Agenda Item # 5 SUB-003151-2024

Hale’s Place Subdivision

- Subdivision approval to create four (4) legal lots of record from four (4) metes-and-bounds parcels.

DETAIL SITE PLAN

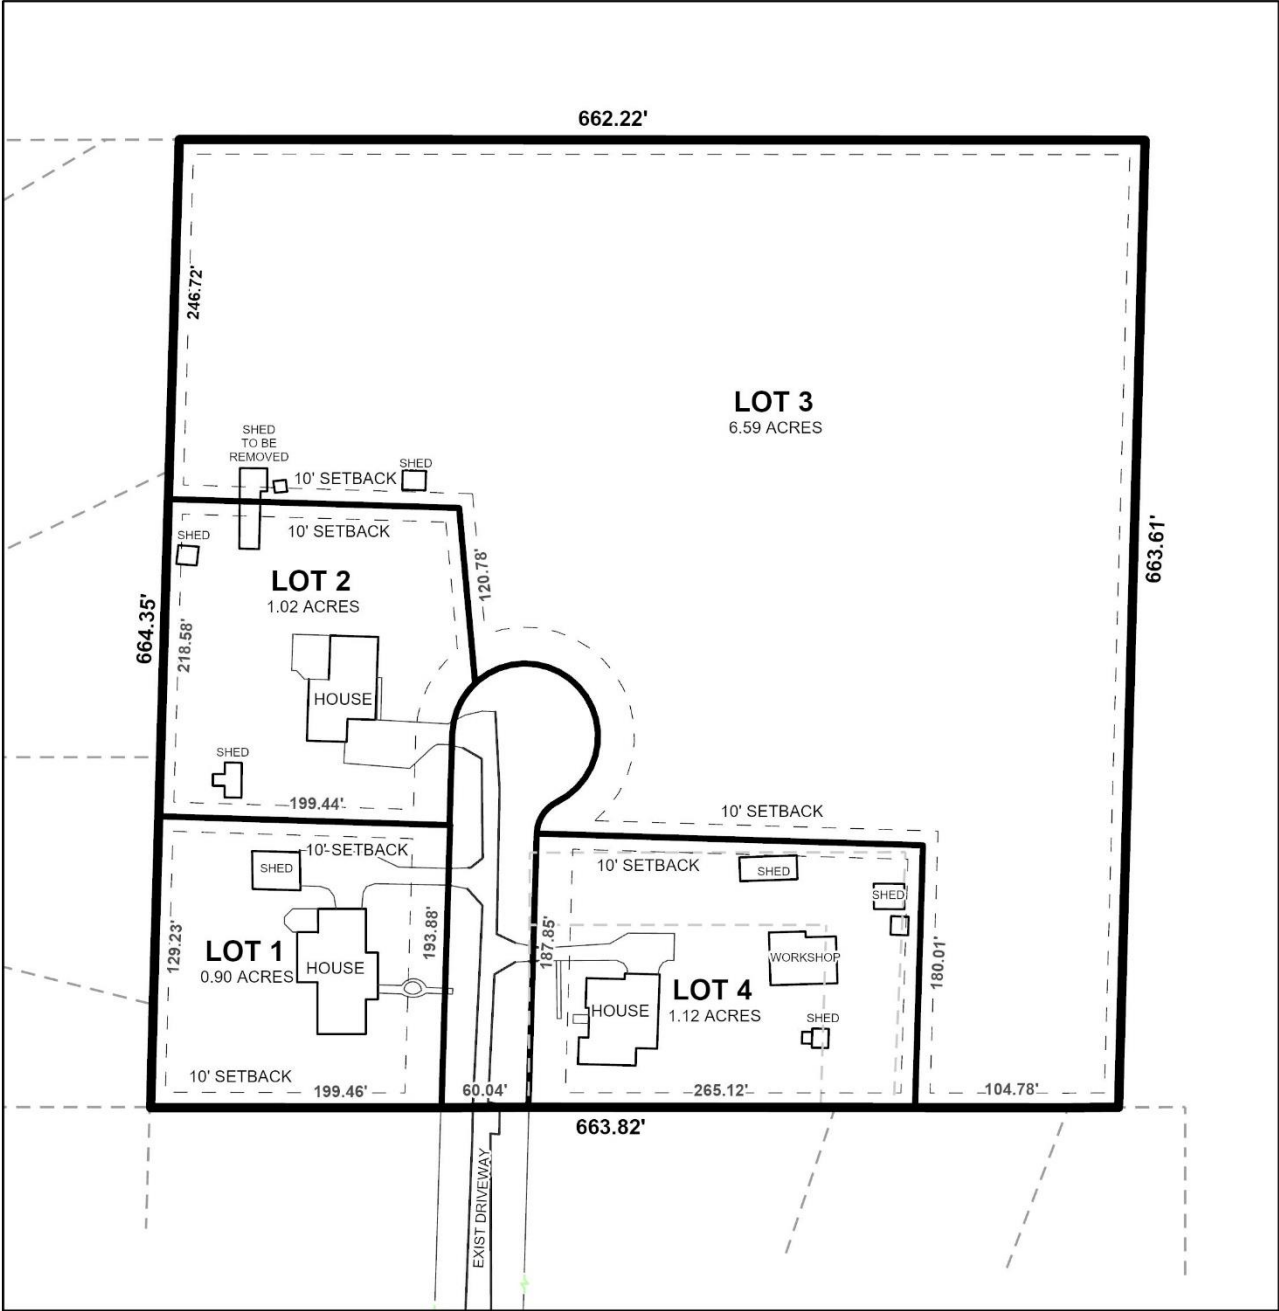
- A. Provide all of the required information on the SUBDIVISION PLAT (i.e. signature blocks, signatures, certification statements, written legal description, required notes, legend, scale, bearings and distances) that is required by the current Alabama State Board of Licensure for Professional Engineers and Land Surveyors.

- B. Label the existing road ROW name (Maple Dr.), width, and whether it is PUBLIC or PRIVATE ROW.
- C. Label the proposed ROW with a name, width, and whether it is PUBLIC or PRIVATE ROW.

- D. Revise the cul-de-sac to the required 60-foot radius.
- E. Show and label the proposed ROW centerline and offset to the cul-de-sac radius point.
- F. Review and revise the written legal description to remove the duplicate call out.

- G. Delete NOTE #1 and replace it with "As shown on the 1984 aerial photo LOTS 1-4 will receive historical credit of existing impervious area towards stormwater detention requirement per Mobile City Code, Chapter 17, Storm Water Management and Flood Control) as follows: LOT 1 – NONE, LOT 2 – NONE, LOT 3 – NONE, AND LOT 4 – NONE.

- H. Add a note that the proposed roadway and stormwater improvements shall be complete and approved prior to issuing any residential construction permits.

As proposed, Lots 1 – 4 do not have direct frontage onto a public street, as required by Section 6.C.4. of the Subdivision Regulations. The preliminary plat does, however, illustrate an existing driveway which grants access to the proposed lots from Maple Drive, a minor street without curb and gutter illustrating a compliant 60-foot right-of-way width. Section 64-3-2.A.1. of the Unified Development Code (UDC) allows access to be provided by a recorded dedicated easement, but a waiver of Section 6.C.4. of the Subdivision Regulations will be required for approval. Such a waiver may be appropriate considering the property has existed in its current configuration since before it was annexed into city limits in 2023. It should be noted that the preliminary plat does not label the existing driveway as an access easement. As such, if approved, the Final Plat should be revised to label the driveway as a non-exclusive ingress/egress access easement.

The preliminary plat illustrates a compliant 25-foot front setback for Lots 1 and 4, however, it mislabels the front setback for Lot 2 and does not provide a front setback label for Lot 3. Additionally, the preliminary plat illustrates 10-foot side and rear yard setbacks for all proposed lots, which is not required by the Subdivision Regulations. As such, if approved, the Final Plat should be revised to illustrate a 25-foot front setback for all proposed lots where they abut the proposed access easement in compliance with Article 2 Section 64-2-5.E. of the Unified Development Code and to remove the side and rear setbacks from the Final Plat.

It should be noted that, as proposed, Lot 3 is irregularly shaped. Section 6.C.1. of the Subdivision Regulations requires the size, width, depth, shape, and orientation of all proposed lots be "compatible and appropriate" to the location of the Subdivision and the type of development and use contemplated. Staff was not provided any information regarding the contemplated use or future development, though existing development has been for residential use. While the proposed layout of Lot 3 is non-standard to residential development there appear to be other irregularly shaped lots within the area. As such, if approved, a waiver of Section 6.C.1. may be appropriate.

Lastly, it should be noted that the preliminary plat illustrates several existing accessory structures (sheds) on various lots that may encroach into the side and rear setbacks. As these lots were developed prior to annexation in 2023 it is possible that the structures may have legal non-conforming status per Article 6 Section 64-6-2 of the Unified Development Code. As such, any future development or redevelopment of these lots may require full compliance with current regulations.

1. Revision of the Final Plat to label the 60-foot driveway as a non-exclusive ingress/egress access easement;
2. Retention of the of the lot sizes in both square feet and acres, or the furnishing of a table on the Final Plat providing the same information;

3. Revision of the Final Plat to illustrate a 25-foot front setback where all lots abut the proposed access easement in compliance with Article 2 Section 64-2-5.E. of the Unified Development Code;

4. Revision of the Final Plat to remove the side and rear setbacks;
5. Retention of the note on the Final Plat stating that no structure shall be constructed in any easement without permission from the easement holder;
